BARANOF INTERBAY STORAGE

DRB Recommendation Package #2

West Design Review Board: Meeting Date 08/31/2016

DPD PROJECT # 3022095

1 WEST ELEVATION
A3.00

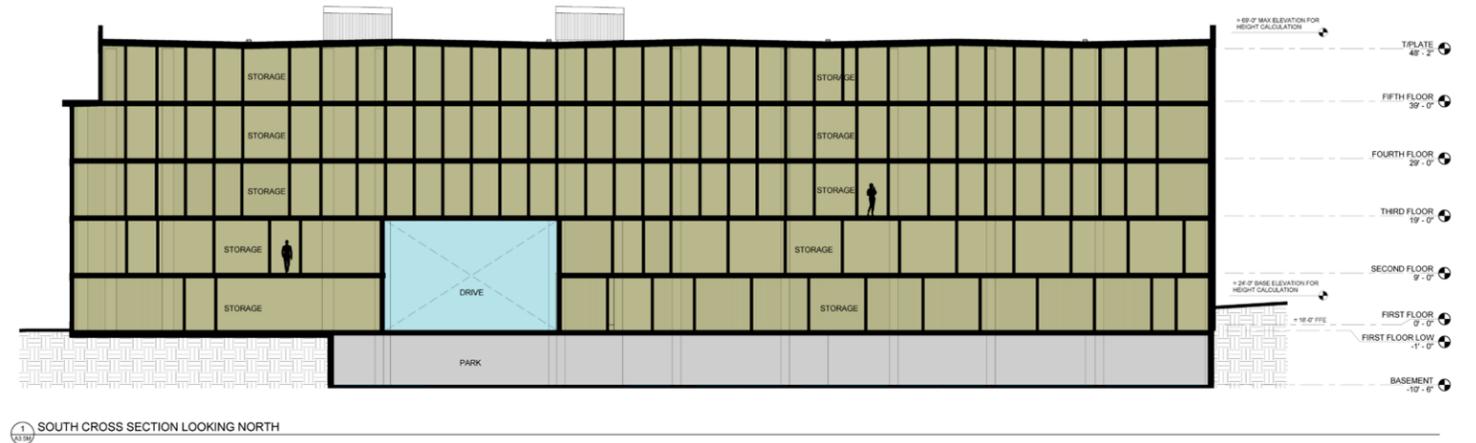
a. Along 15th Ave W, the structure is recessed approximately five-feet near the center of the elevation and treated with green metal panel. The Board agreed this modulation should be increased to further emphasize the perception of the project as two structures. (CS2-C, DC2-A)

b. In consideration of pedestrian safety along 15th Ave W, the Board agreed the modulation should happen at floors two and up so as to maintain a consistent street edge and ensure pedestrian safety (PL2-B).

Response: From the meeting, the Design Team understood the primary concern to be two fold; the overall mass of a single, unbroken upper structure and the large, unadorned walls on the West elevation. In working through the design, the Design Team did not see the cutting away of the slot area as successfully achieving either goal. To meet the objective of reduced perceived mass of the upper structure and minimization of the blank wall, we have cut the building twice on the West elevations upper levels, recessed it on the third floor and projected out the ground floor as requested. In combination with the landscape changes, we believe this to be a more successful response to meet both the massing and blank wall objectives identified. Further, the parapet has been stepped to increase the visual relief along each of the buildings elevations.

Response: Along W. 15th Avenue, the proposed building façade maintains a constant plane relative to the street edge. The square arches in green break up the elevation into the three sections which are separated by each other by clear glazing and narrow wall sections of metal panel to further articulate the façade.
